**Nomination Form  
Anadromous Waters Catalog**

Anadromous Waters Catalog Number of Water Body 103-60-10560

Nomination # <u>23-666</u>	<u>Adam Rimm</u> Fisheries Scientist	<u>1-28-2024</u> Date
Revision Year: <u>2024</u>	<u>Ron Benkert</u> Habitat Operations Manager	<u>1-4-2024</u> Date
Revision to: <input checked="" type="checkbox"/> Atlas <input checked="" type="checkbox"/> Catalog	<u>[Signature]</u> AWC Project Biologist	<u>19 Dec 2023</u> Date
Revision Code: <u>C-9, C-7, D-1</u>	<u>[Signature]</u> GIS Analyst	<u>1/30/24</u> Date

**~RELOCATE/UPDATE hydrography & mouth location and; SHORTEN current upper reach of existing AWC Stream #103-60-10560.**

Map #1

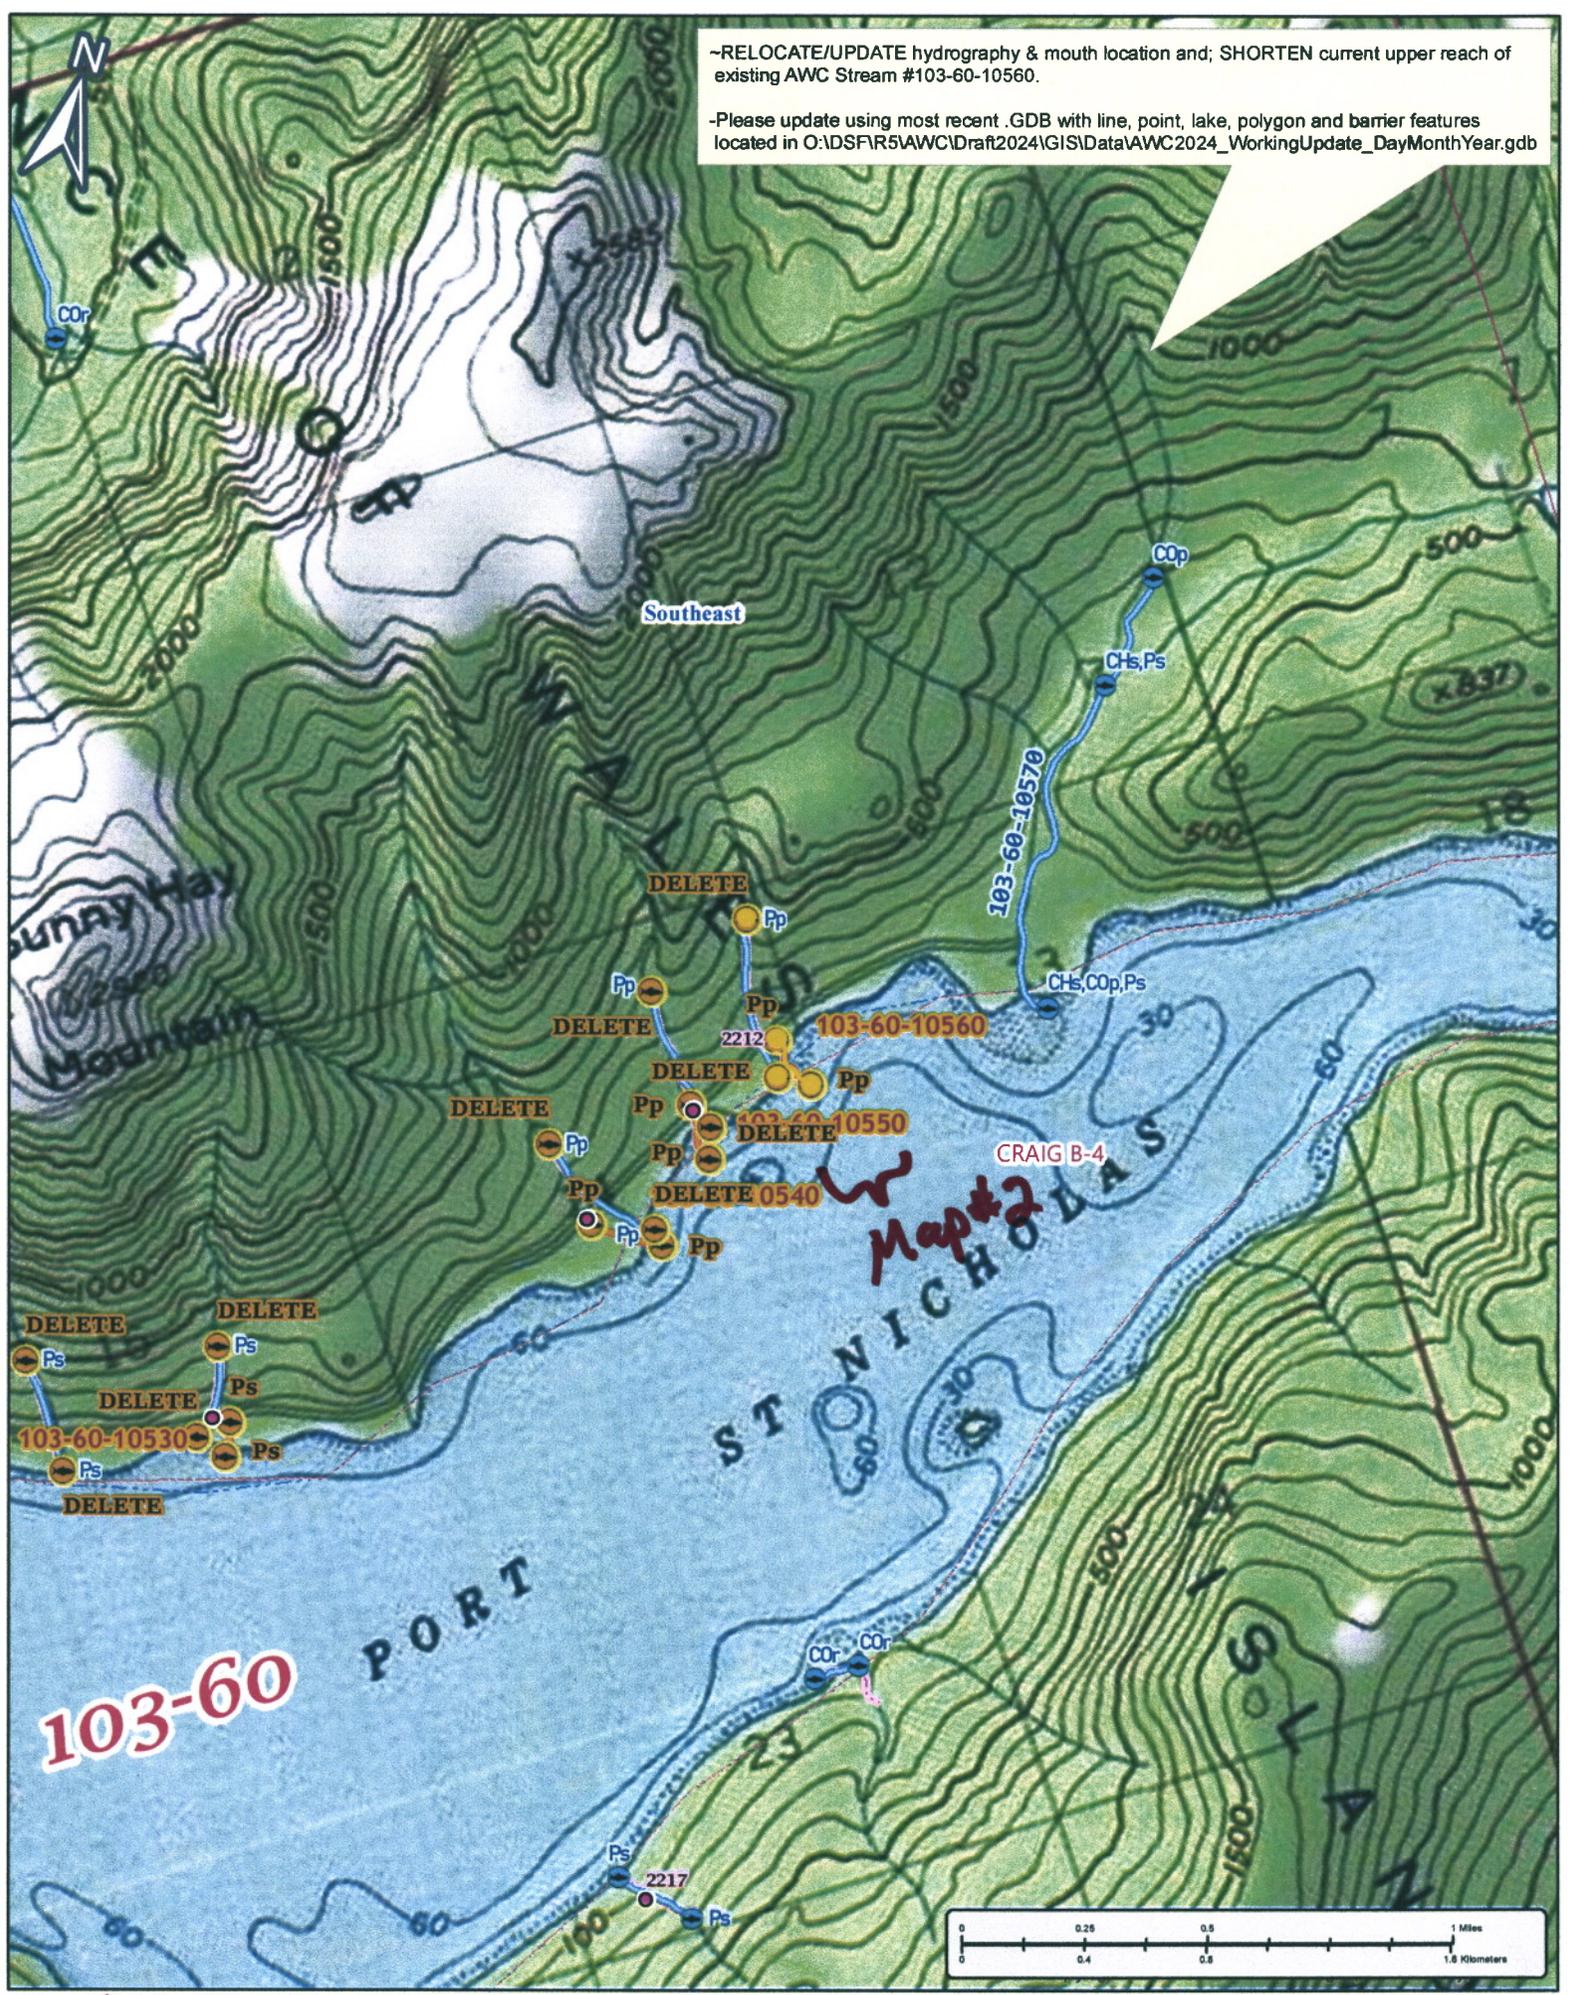
← Shows landslide  
in upper reach  
of stream above  
road crossing.

-RELOCATE/UPDATE hydrography & mouth location and; SHORTEN current upper reach of existing AWC Stream #103-60-10560.  
-Please update using most recent .GDB with line, point, lake, polygon and barrier features located in O:\DS\FR5\AWC\Draft2024\GIS\Data\AWC2024\_WorkingUpdate\_DayMonthYear.gdb

-RELOCATE/UPDATE hydrography & mouth location and; SHORTEN current upper reach of existing AWC Stream #103-60-10560.
